SUBJECT: **ADDENDUM #1 TO THE BIDDING DOCUMENTS FOR:
NORTH HIGH SCHOOL BID GROUP#01**
NORTH AND SOUTH HIGH SCHOOL HVAC PROJECT 2022
COMMUNITY HIGH SCHOOL DISTRICT 99
NORTH HIGH SCHOOL
4436 MAIN STREET
DOWNERS GROVE, IL 60516
SOUTH HIGH SCHOOL
1436 NORFOLK STREET
DOWNERS GROVE, IL 60516

This addendum forms a part of the Bidding Contract Documents, dated November 30th, 2021. Bidders must acknowledge receipt of this Addendum in the space provided on the Bid Form.

- Mechanical Drawings:
MD2.02E.S;M2.02E.S;M5.02.S
- Electrical Drawings:
E2.02E.S; E2.04G.S; E2.04H.S;E3.00S; ED2.02E.S; ED2.04G.S; ED2.04H.S
- Question and Answer Log
- 004100 HVAC Scope
- 004101 HVAC Bid Form

MD2.02E.S

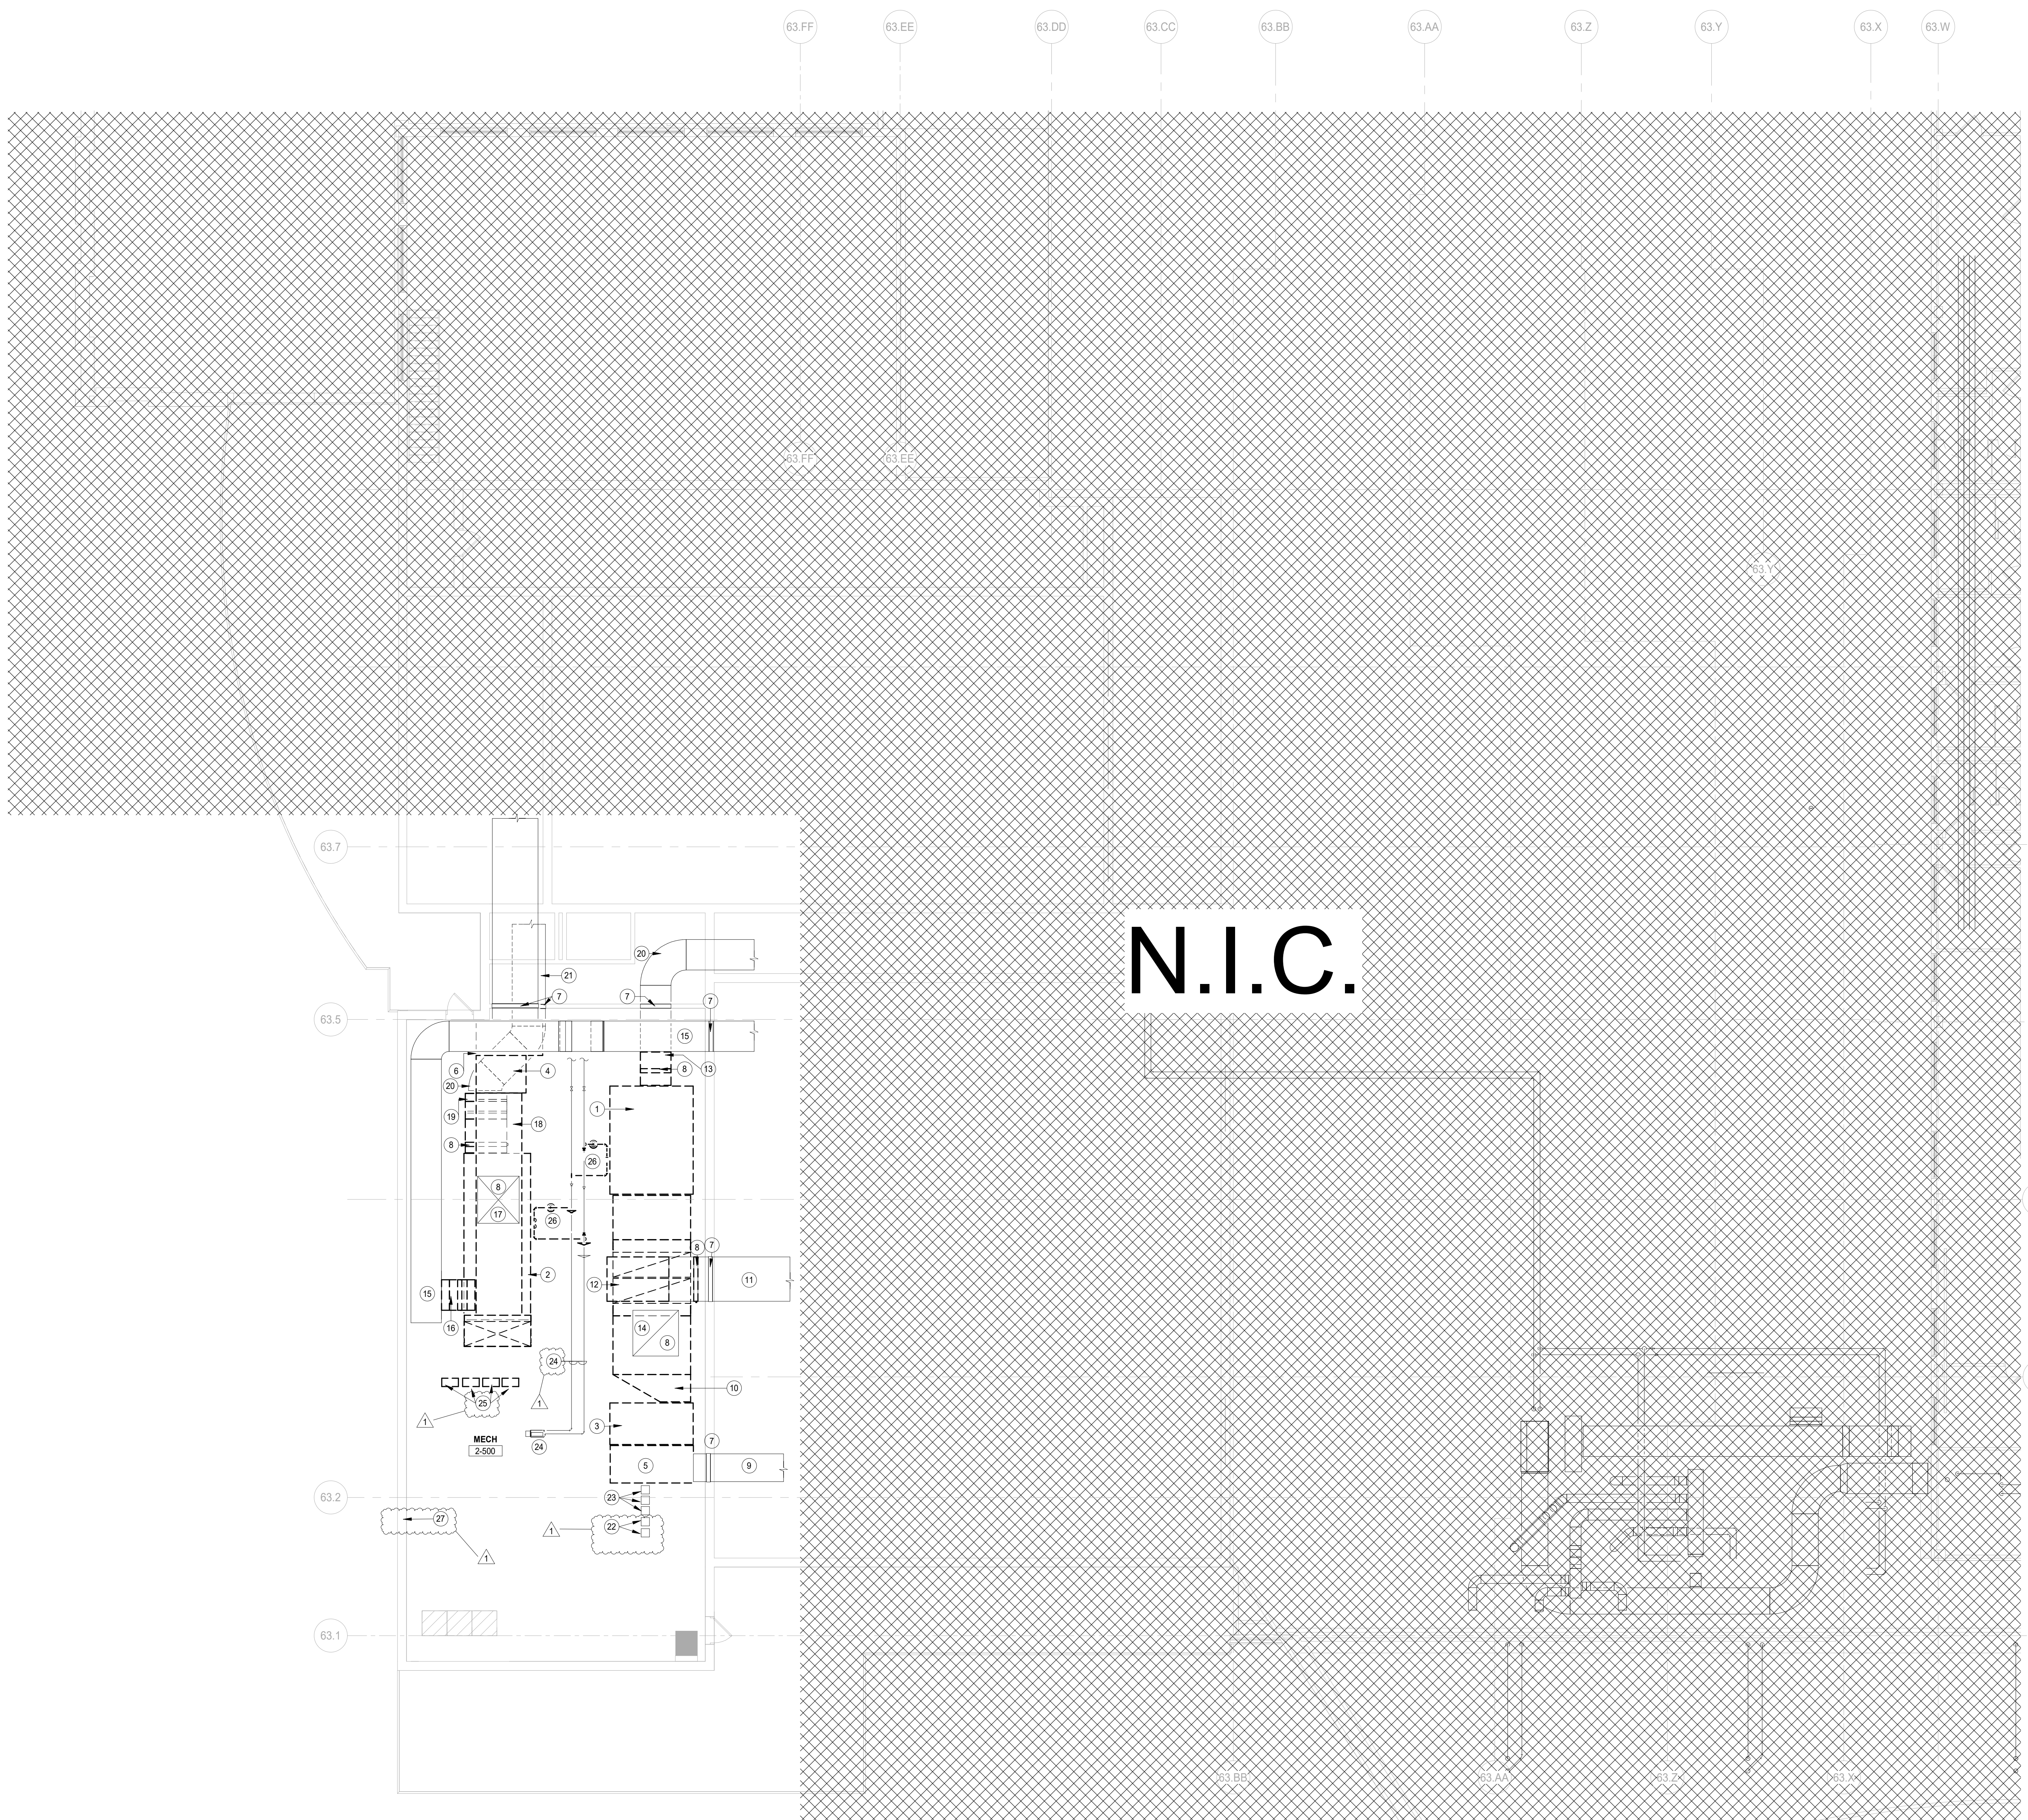
- KEYNOTES**
- DEMOLISH EXISTING AIR HANDLING UNIT AH-5. EXISTING CONCRETE PAD TO REMAIN.
 - DEMOLISH EXISTING AIR HANDLING UNIT AH-4. EXISTING CONCRETE PAD TO REMAIN.

- DEMOLISH EXISTING EXHAUST FAN ER-6.
 - DEMOLISH EXISTING EXHAUST FAN ER-4.
 - DEMOLISH EXISTING RETURN AIR PLENUM FOR ER-6.
 - DEMOLISH EXISTING RETURN AIR PLENUM FOR ER-4.

- EXISTING FIRE DAMPERS IN ALL THE EXISTING DUCTS TO REMAIN.
 - EXISTING MOTORIZED DAMPER AND ACTUATOR TO BE DEMOLISHED IN LOCATIONS INDICATED.
 - PORTION OF EXISTING RETURN AIR DUCT TO REMAIN AS SHOWN.

- RETURN AIR DUCT FROM THE OUTLET OF THE EXHAUST FAN ER-6 UP TO THE INLET OF AIR HANDLING UNIT AH-5 TO BE DEMOLISHED.
 - PORTION OF EXISTING OUTSIDE AIR DUCT TO REMAIN AS SHOWN.

- PORTION OF OUTSIDE AIR AND MIXED AIR DUCT TO BE DEMOLISHED AS SHOWN.
 - PORTION OF SUPPLY AIR DUCT TO BE DEMOLISHED AS SHOWN. EXISTING SMOKE DETECTOR TO BE DEMOLISHED.

- EXISTING RELIEF AIR DUCT TO REMAIN. RELIEF AIR HOOD ON ROOF TO REMAIN TOO. THE MOTORIZED AIR DAMPER AND ACTUATOR IN THE RELIEF AIR DUCT TO BE DEMOLISHED.

- EXISTING OUTSIDE AIR DUCT TO REMAIN AS SHOWN.
 - PORTION OF OUTSIDE AIR DUCT CONNECTION TO RETURN AIR DUCT TO BE DEMOLISHED. THE MOTORIZED AIR DAMPER AND ACTUATOR IN THE RELIEF AIR DUCT TO BE DEMOLISHED TOO.

- EXISTING RELIEF AIR DUCT TO REMAIN. RELIEF AIR HOOD ON ROOF TO REMAIN TOO. THE MOTORIZED AIR DAMPER AND ACTUATOR IN THE RELIEF AIR DUCT TO BE DEMOLISHED.

- RETURN AIR DUCT FROM THE OUTLET OF THE EXHAUST FAN ER-4 UP TO THE INLET OF AIR HANDLING UNIT AH-4 TO BE DEMOLISHED.
 - PORTION OF SUPPLY AIR DUCT TO BE DEMOLISHED AS SHOWN. EXISTING SMOKE DETECTOR TO BE DEMOLISHED.

- REST OF THE EXISTING SUPPLY AIR DUCT TO REMAIN AS IS.
 - REST OF THE RETURN AIR DUCT TO REMAIN AS IS.
 - EXISTING DISCONNECTS SERVING EXISTING RECIRCULATION PUMPS TO REMAIN.

- THE DISCONNECT SWITCHES TO REMAIN AS IS.
 - EXISTING HOT WATER HEATER AND EXISTING HOT WATER PIPING TO REMAIN AS IS.
 - DEMOLISH EXISTING VFDS SERVING AH-4, AH-5, ER-4 AND ER-6. DEMOLISH ALL WIRING BETWEEN UNITS AND THE VFD. DEMOLISH SUPPORT ON WHICH VFDS WERE INSTALLED.

- DEMOLISH EXISTING HOT WATER RECIRC PUMPS AND BRANCH PIPING WITH VALVES AS SHOWN.
 - A 6" WIDE PORTION OF EXTERIOR WALL BELOW AN EXISTING LOUVER WILL HAVE TO BE DEMOLISHED AND A PLUMBING VENT PIPE WILL HAVE TO BE REMOVED AND LATER RECONNECTED IN ORDER TO ENABLE BRINGING IN THE NEW AIR HANDLING UNITS. COORDINATE WITH WIGHT CONSTRUCTION FOR

1 MECHANICAL DUCT FLOOR PLAN LEVEL 2 AREA E
 SCALE: 1/8" = 1'-0"

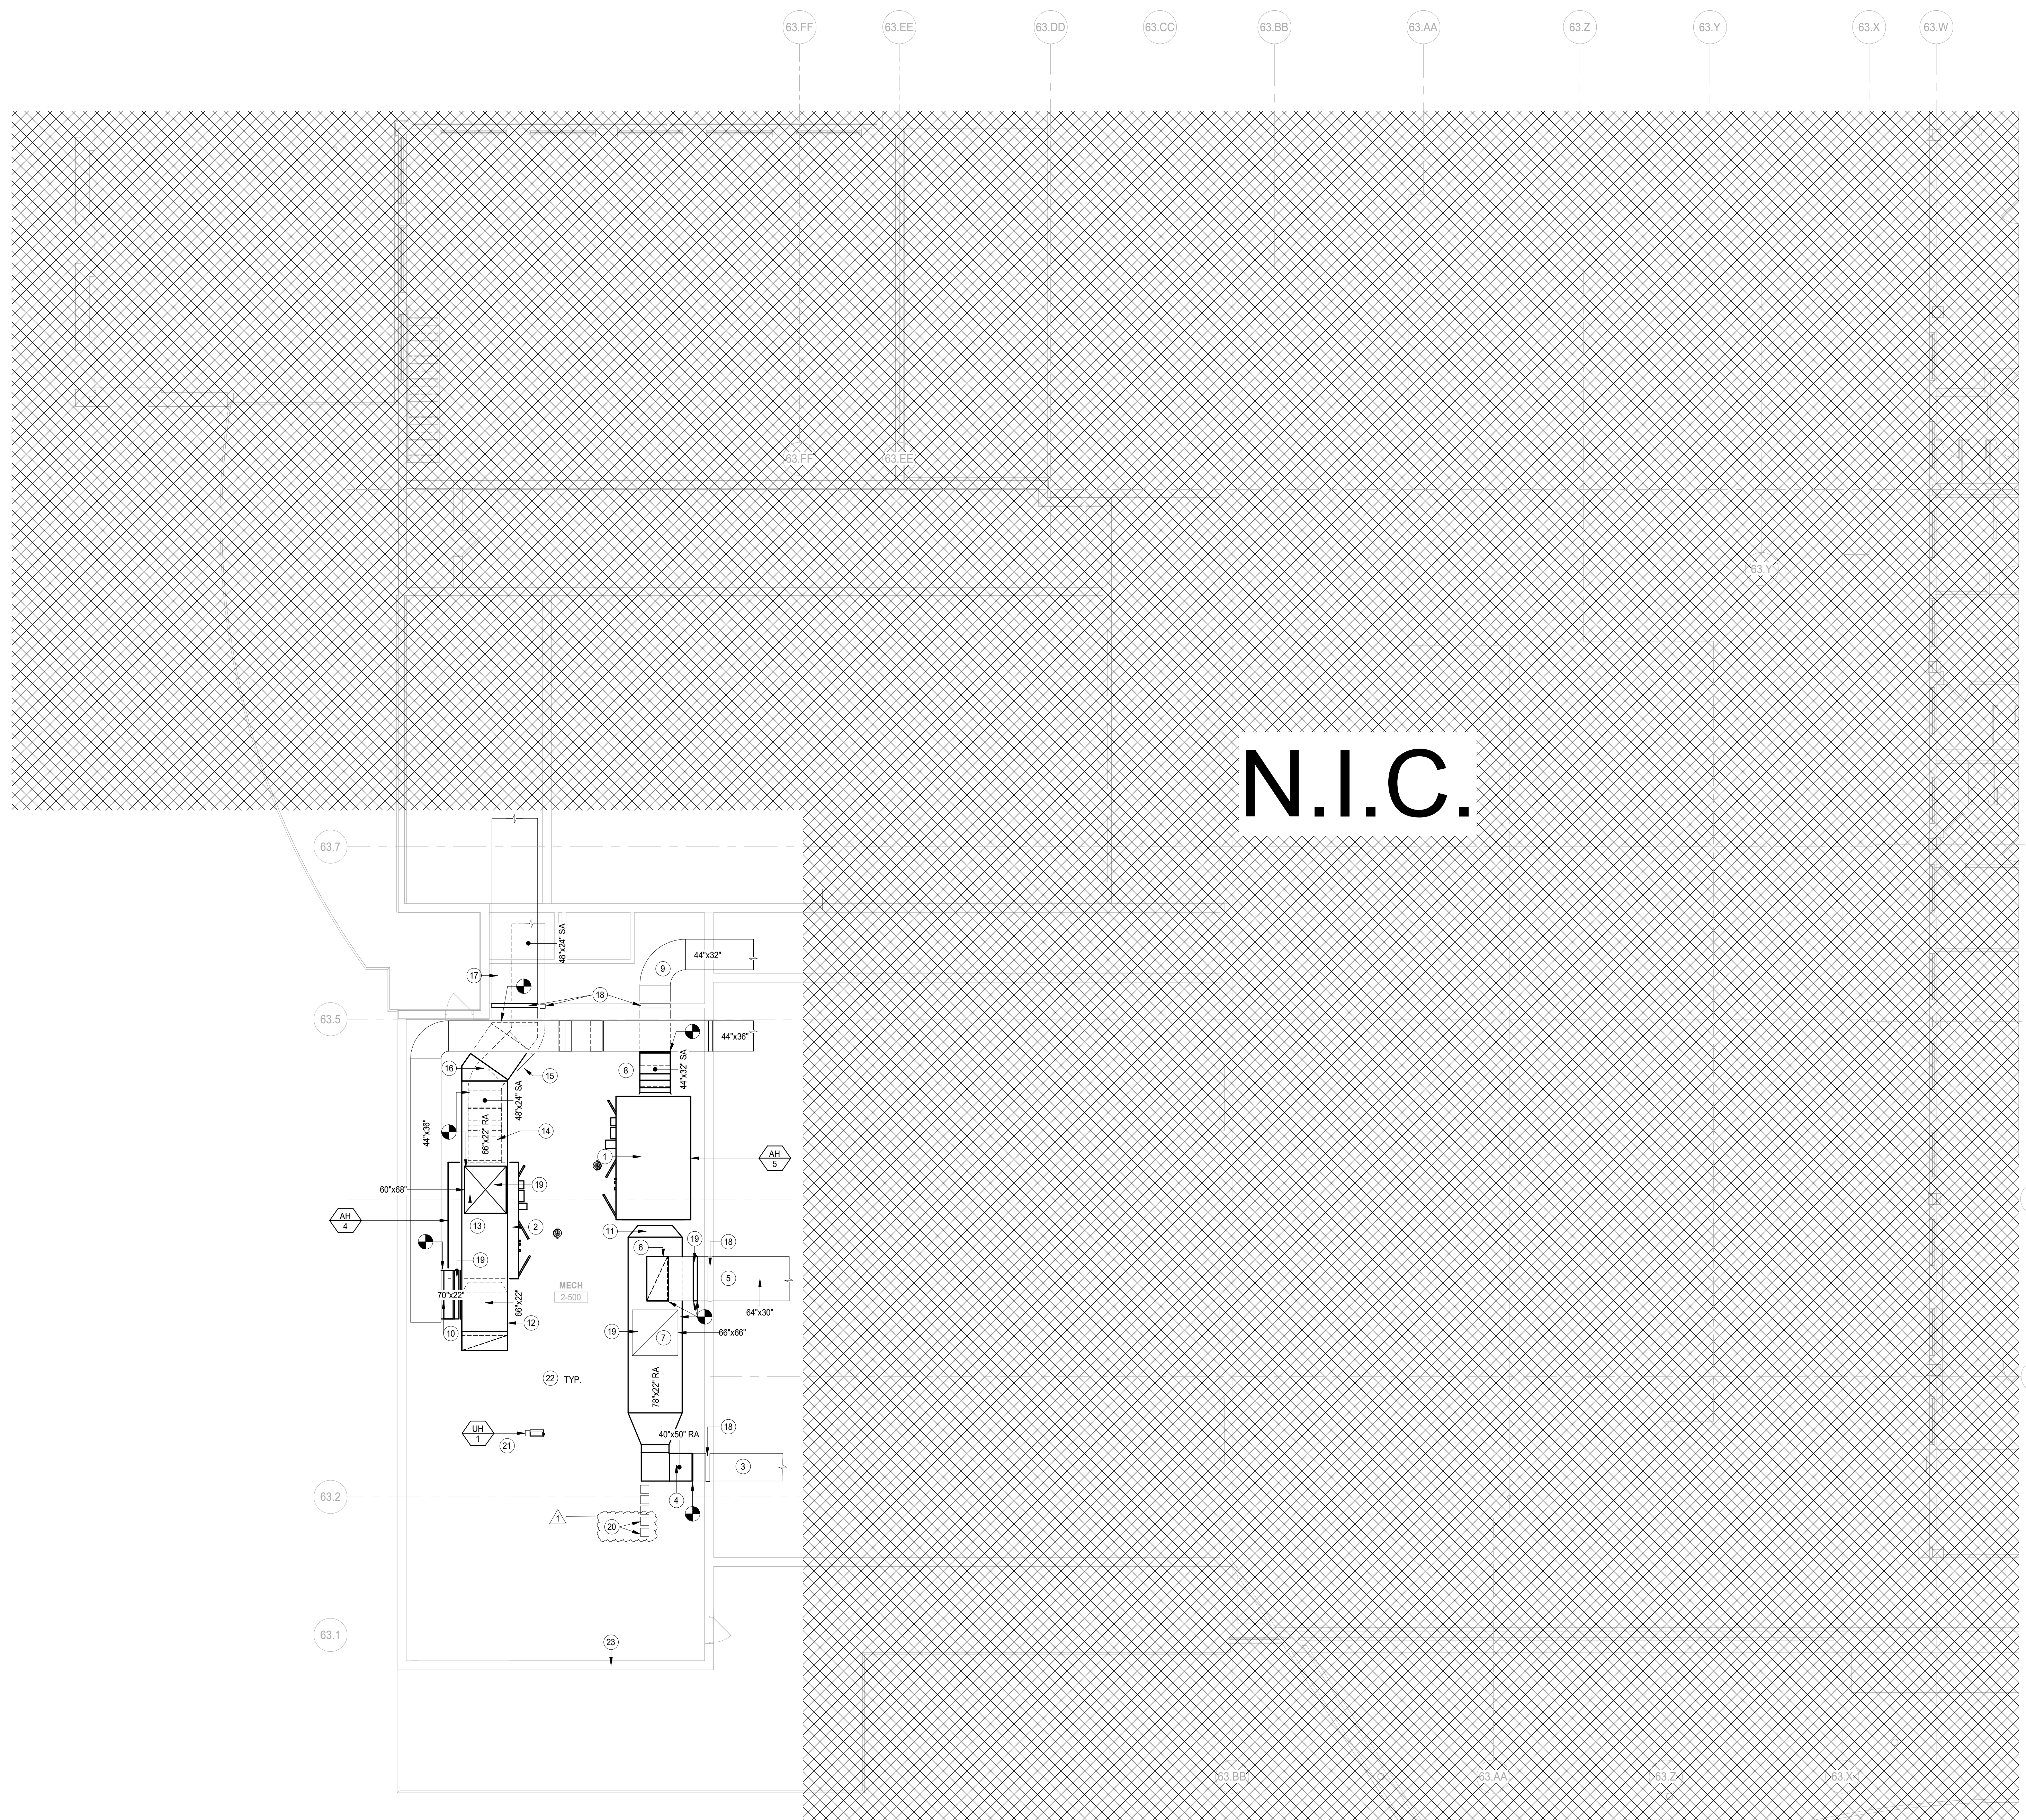
- KEYNOTES**
- 1 PROVIDE NEW AIR HANDLING UNIT AH-5. INSTALL ON EXISTING CONCRETE PAD. THE EXISTING CONCRETE PAD MIGHT NEED TO BE ENLARGED TO ACCOMMODATE THE NEW UNIT.

- 2 PROVIDE NEW AIR HANDLING UNIT AH-4. INSTALL ON EXISTING CONCRETE PAD. THE EXISTING CONCRETE PAD MIGHT NEED TO BE ENLARGED TO ACCOMMODATE THE NEW UNIT.

- 3 EXISTING RETURN AIR DUCT TO REMAIN AS SHOWN.
 - 4 PROVIDE NEW RETURN AIR DUCT AS SHOWN. CONNECT TO EXISTING RETURN AIR DUCTWORK.
 - 5 EXISTING OUTSIDE AIR DUCT TO REMAIN AS SHOWN. CONNECT TO NEW OUTSIDE AIR DUCT.

- 6 CONNECT NEW OUTSIDE AIR DUCT TO NEW RETURN AIR DUCT.
 - 7 EXISTING RELIEF AIR DUCT TO REMAIN. RELIEF HOOD ON ROOF TO REMAIN. TOO. SOME PORTION OF DUCT WILL HAVE TO BE NEW IN ORDER TO ENABLE CONNECTION WITH NEW RETURN AIR DUCT. PROVIDE NEW MOTORIZED DAMPER AND ACTUATOR. CONNECT TO NEW RETURN AIR DUCT.

- 8 PROVIDE NEW SUPPLY AIR DUCT CONNECTION FROM NEW AH-5 TO EXISTING SUPPLY AIR DUCT. PROVIDE DUCT SMOKE DETECTORS.
 - 9 EXISTING SUPPLY AIR DUCT TO REMAIN AS IS. T&B CONTRACTOR TO CONTACT EOR FOR EXISTING DRAWINGS IN ORDER TO BALANCE EXISTING DUCTWORK.

- 10 PROVIDE NEW OUTSIDE AIR DUCT CONNECTION TO NEW RETURN AIR DUCT. PROVIDE NEW MOTORIZED DAMPER WITH ACTUATOR.
 - 11 TRANSITION RETURN AIR DUCT TO CONNECT TO RETURN AIR CONNECTION AT AH-5.

- 12 PROVIDE NEW RETURN AIR DUCT OF SIZE SHOWN.
 - 13 EXISTING RELIEF AIR DUCT TO REMAIN. RELIEF HOOD ON ROOF TO REMAIN. TOO. SOME PORTION OF DUCT WILL HAVE TO BE NEW IN ORDER TO ENABLE CONNECTION WITH NEW RETURN AIR DUCT. PROVIDE NEW MOTORIZED DAMPER AND ACTUATOR. CONNECT TO NEW RETURN AIR DUCT.

- 14 PROVIDE NEW SUPPLY AIR DUCT CONNECTION FROM NEW AH-4 TO EXISTING SUPPLY AIR DUCT. PROVIDE DUCT SMOKE DETECTORS.
 - 15 EXISTING SUPPLY AIR DUCT TO REMAIN AS IS. T&B CONTRACTOR TO CONTACT EOR FOR EXISTING DRAWINGS IN ORDER TO BALANCE EXISTING DUCTWORK.

- 16 NEW RETURN AIR DUCT TO BE PROVIDED AS SHOWN.
 - 17 REST OF THE RETURN AIR DUCT TO REMAIN AS IS. T&B CONTRACTOR TO CONTACT EOR FOR EXISTING DRAWINGS IN ORDER TO BALANCE EXISTING DUCTWORK.

- 18 EXISTING FIRE DAMPERS IN ALL EXISTING DUCTS TO REMAIN AS IS.
 - 19 PROVIDE NEW MOTORIZED DAMPERS WITH ACTUATORS.
 - 20 REUSE EXISTING DISCONNECT SWITCHES FOR NEW HOT WATER RECIRC PUMPS.

- 21 EXISTING UNIT HEATER TO REMAIN.
 - 22 ALL DUCTWORK TO BE INSULATED PER SPECIFICATIONS.
 - 23 A 8" WIDE PORTION OF EXTERIOR WALL BELOW AN EXISTING LOUVER WILL HAVE TO BE DEMOLISHED AND A PLUMBING VENT PIPE WILL HAVE TO BE REMOVED AND LATER RECONNECTED IN ORDER TO ENABLE BRINGING IN THE NEW AIR HANDLING UNITS. COORDINATE WITH WIGHT CONSTRUCTION FOR THIS WORK.
